# PANDUIT PRODUCT SAFETY ADVISORY (PSA)

Reference: PSA09182018001

## IMPORTANT SAFETY INFORMATION REGARDING PANDUIT UNINTERRUPTIBLE POWER SUPPLIES (UPS) AND NETWORK ZONE SYSTEMS WITH UNINTERRUPTIBLE POWER SUPPLIES

**FIGURE 1**

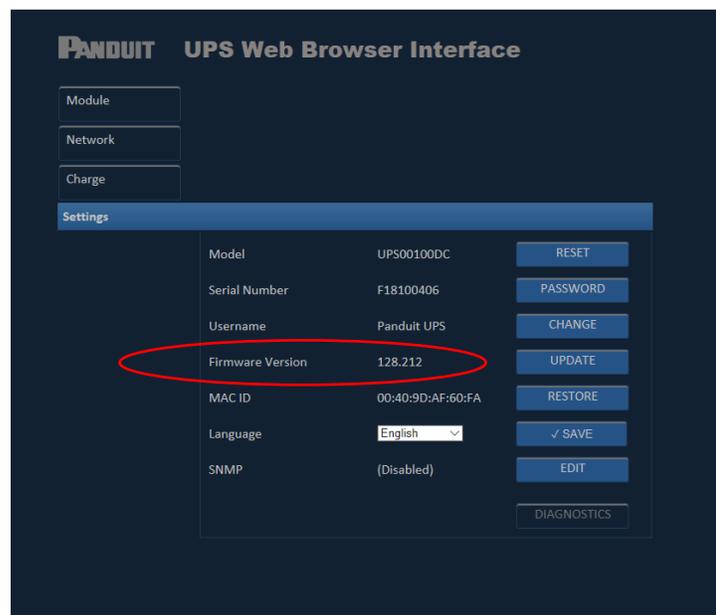
**POTENTIAL FAILURE.** Under certain conditions, Panduit Uninterruptible Power Supplies (UPS) and Network Zone Systems with UPS contain capacitors that may fail, and vent or leak hazardous substances onto the outside of the UPS housing. When this occurs, the leaked substances may cause potential safety hazards and the UPS will eventually stop operating.

**POTENTIAL SAFETY HAZARDS.** The capacitor is an electronic product that contains primarily non-hazardous materials, but the sealed capacitors contain two potentially hazardous substances, acetonitrile and Tetraethylammonium tetrafluoroborate. If the UPS is charged at a high level and/or the temperature of the capacitor exceeds the suggested operating temperature at its given lifetime (see User Manual for suggested charging and operating temperatures

<https://www.panduit.com/content/dam/panduit/en/products/assets/u/up/ups/ups0/ups00100dc/media/N-PUCD-0009--REV04--ENG.pdf>), these hazardous substances may vent or leak onto the outside of the UPS housing. A failed unit can present itself as a white powder on the lowest part of the UPS. Figure 1 shows a UPS where the ultracapacitors have vented.

***If you have an Affected Product, visually inspect the UPS for signs of leaking as shown in Figure 1. Do not install the Firmware Update if there are visual signs that the capacitors are leaking. Instead, remove the unit from service and replace it, following the PRECAUTIONS section of this PSA.***

**REQUESTED CUSTOMER ACTION TO PREVENT HAZARD.** To mitigate the risk of these safety hazards occurring, Panduit has created a firmware update which, when installed, will automatically notify the user when the unit has vented, shut down the operation of the UPS, and inform the user that replacement of the UPS is required.

***If there are no signs of leaking then install the new Firmware Update.***
